Re: United States Patent No. 7,198,162 B2
Issued: April 3, 2007
Inventor(s): Francois et al.
For: Molded Closure and Apparatus for Making Same

**UNITED STATES PATENT AND TRADEMARK OFFICE
CERTIFICATE OF CORRECTION**Page 1 of 1

AMENDMENT D UNDER 37 CFR 111

FIG. 2

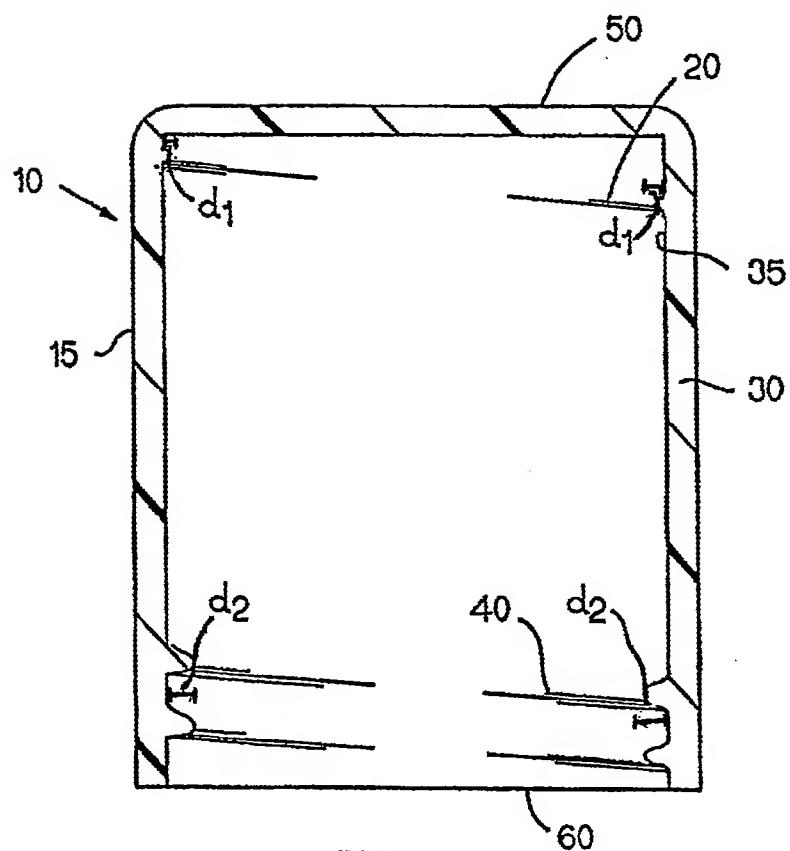
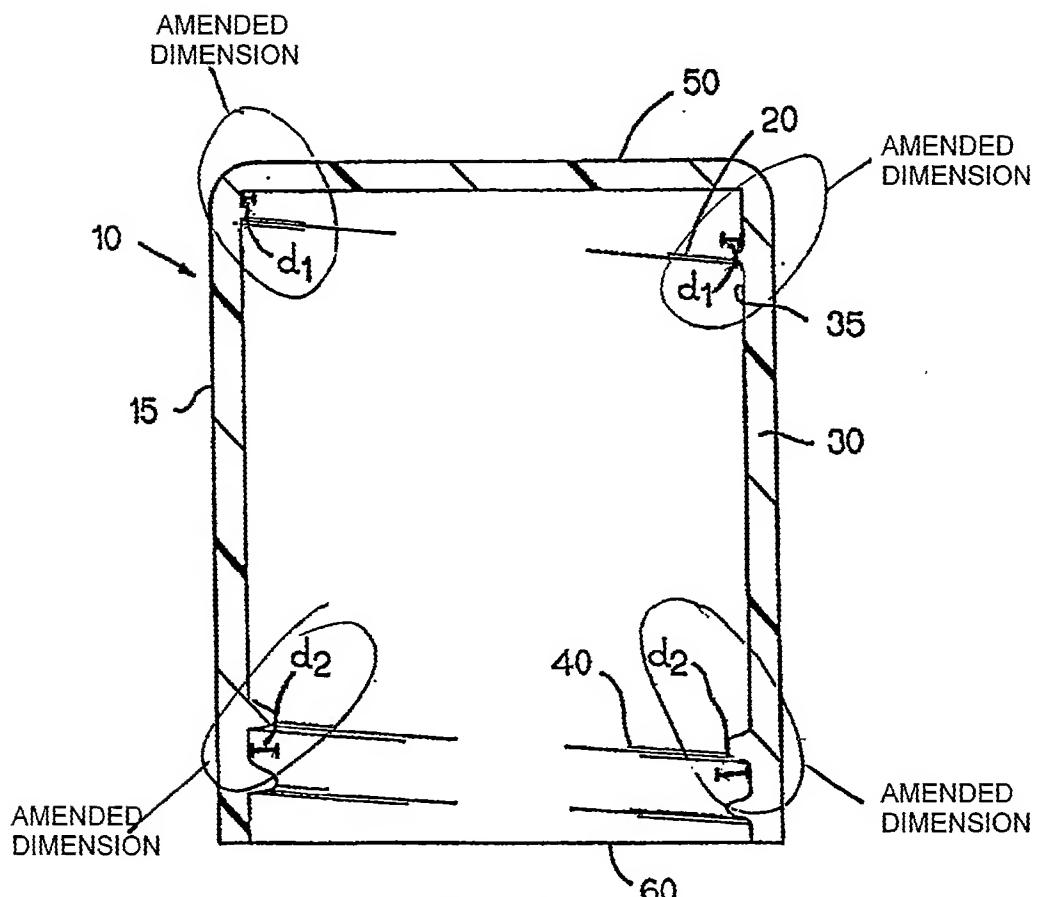
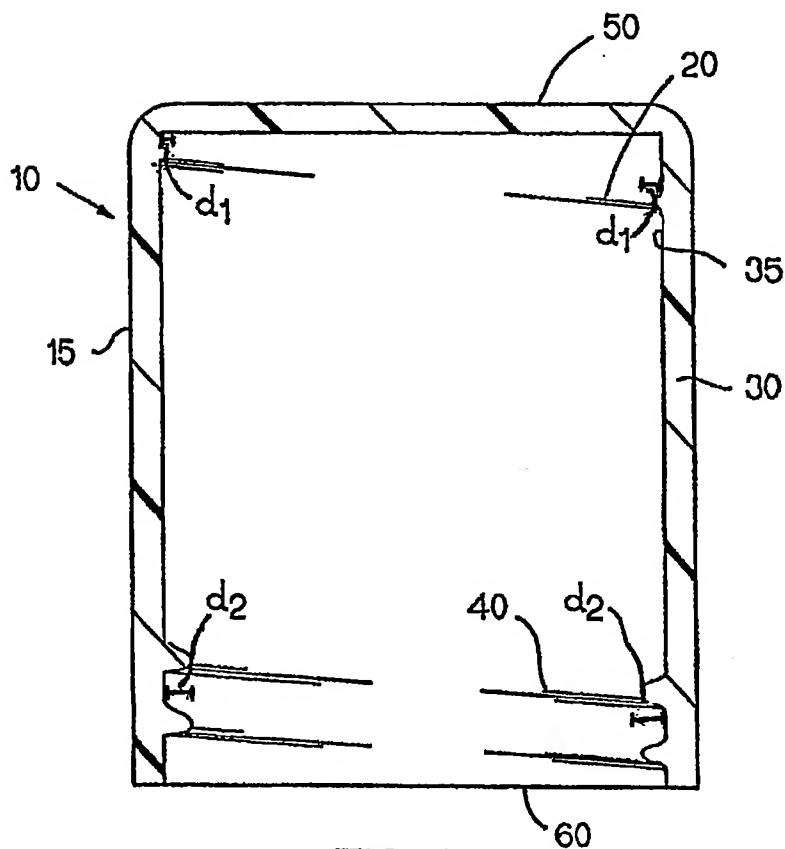
Replacement Drawings, Figures 2 and 6 are attached after page 10; and,

Annotated Drawings, Figures 2 and 6 are attached after the replacement drawings.

Applicant has amended Figure 2 to properly depict the thread depth dimension d_1 and d_2 . It has come to the attention of the Applicants’ attorney that the drawing is improperly labeled and that the descriptions previously provided to the Examiner have not been understood by the Examiner. The application clearly refers to the depth as the distance between the point of attachment to the wall of the closure and its point of greatest displacement therefrom. P. 9, lines 13-15. Further, in Office Action Response B, Applicant’s attorney stated that the teachings of the cited prior art reference were not related to the depth, the distance radially inward from the closure sidewall. See page 11, lines 10-11. Therefore, the Applicants’ attorney believes that the Examiner has misunderstood this term due to the drawings without carefully reading the disclosure. Applicants’ attorney submits this drawing change does not include new matter. Such drawing change has also been made in Figure 6.
